Work Order ID 97955

Item ID: D206-642-541

Item Name: Replacement Skidtube

DRAWING NO. D3274	TITLE SKIDTUBE ASSEMBLY	REV. D	DART AEROSPACE USA, INC ENGINEERING ORDER		D.E.O. NO. D3274-D-1	SHEET NO. SHEET 1 OF 1	SCALE NTS
DRAWN CP	CHECKED	MFG. APPR.	APPROVED		DE APPR.		
DATE 09.06.17	DATE 09.06.23	DATE 09/06/23	DATE 09/06/23		DATE 09.06.23

DETAIL F: END FINISHING DETAIL

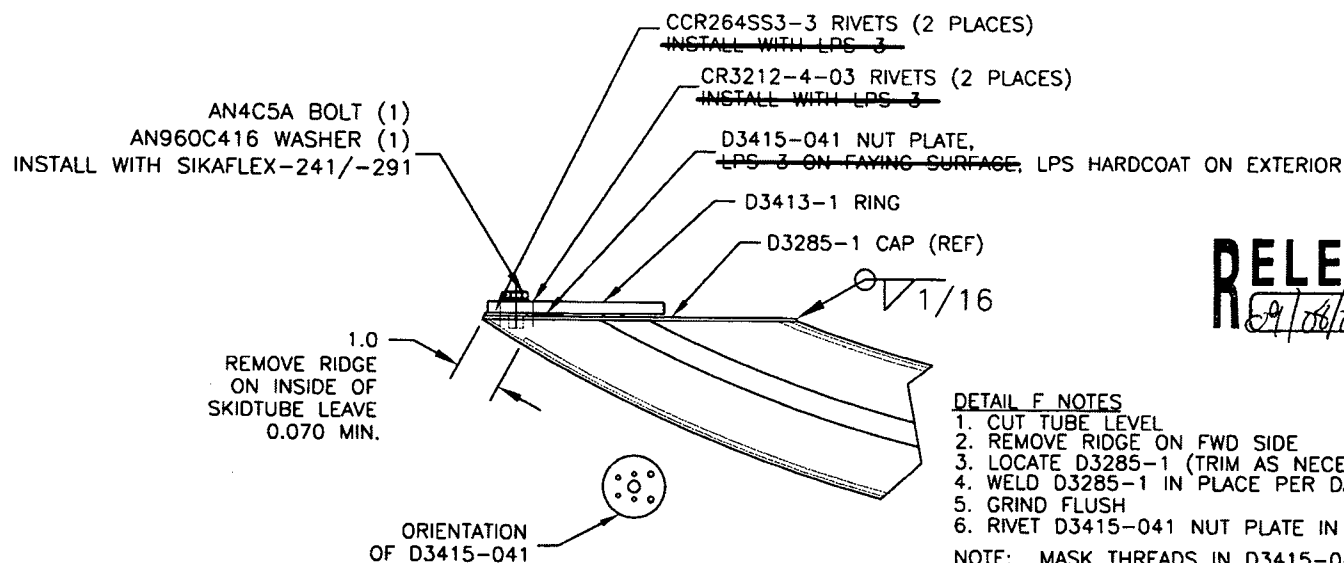
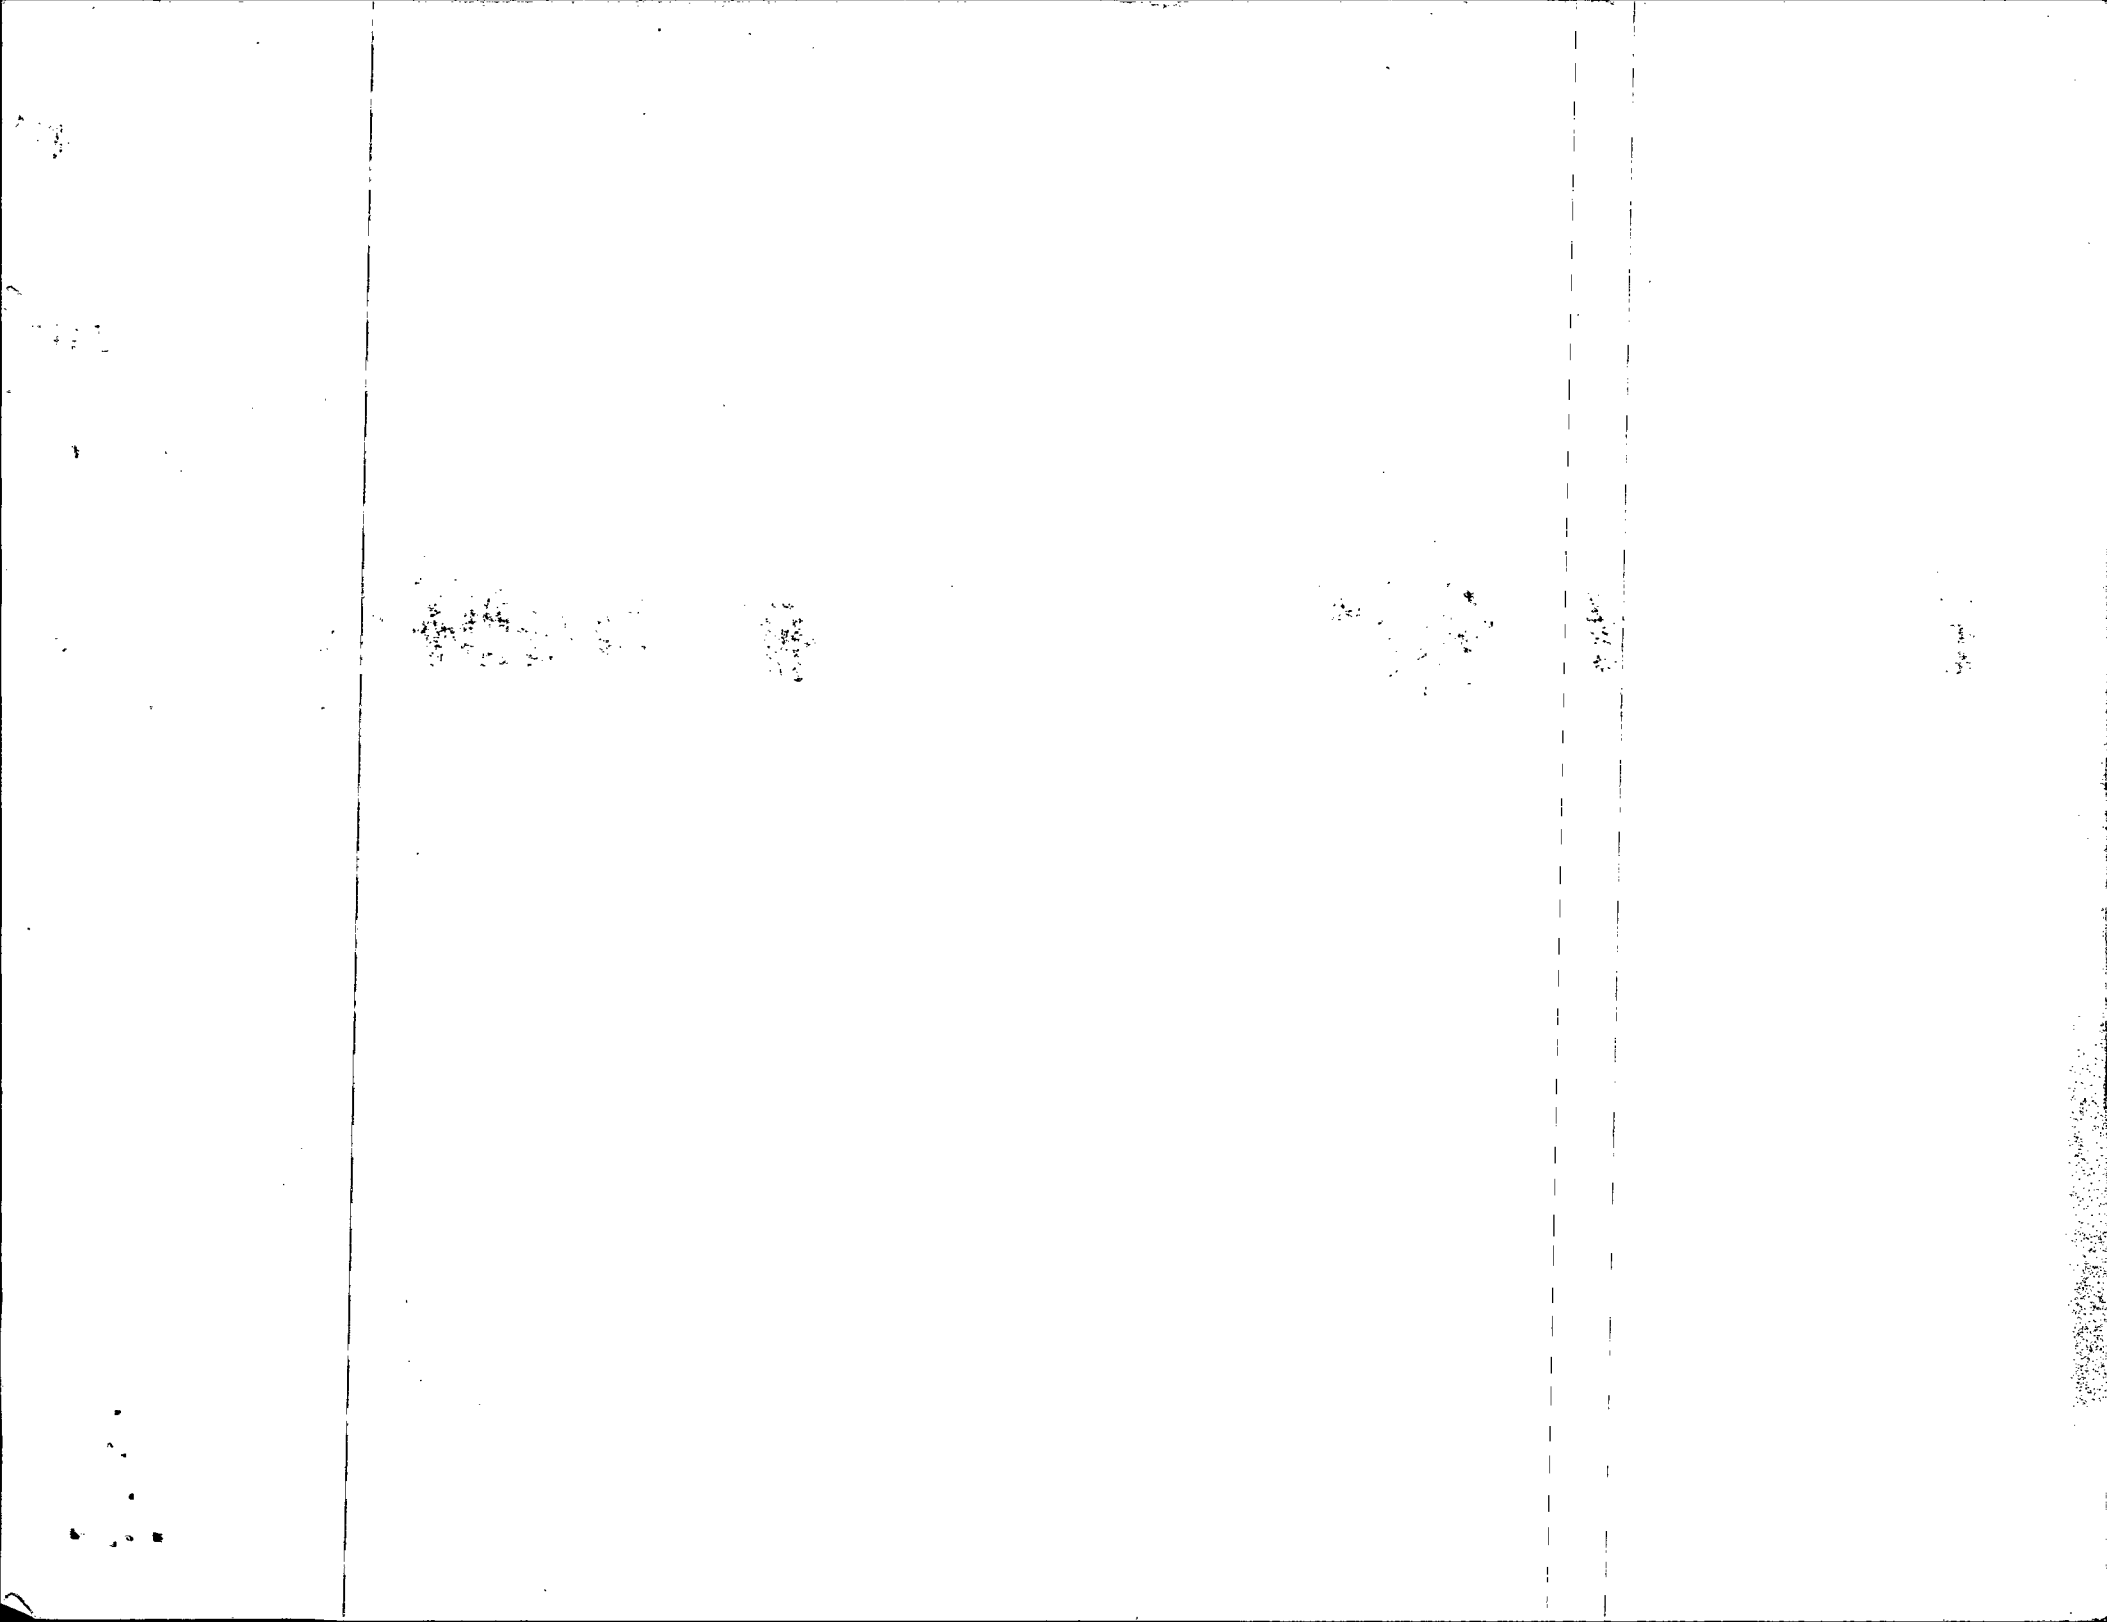
AMEND DETAIL F AS SHOWN:

1. CUT TUBE LEVEL
2. REMOVE RIDGE ON FWD SIDE
3. LOCATE D3285-1 (TRIM AS NECESSARY)
4. WELD D3285-1 IN PLACE PER DART QSI 004
5. GRIND FLUSH
6. RIVET D3415-041 NUT PLATE IN PLACE

NOTE: MASK THREADS IN D3415-041
PRIOR TO FINISH
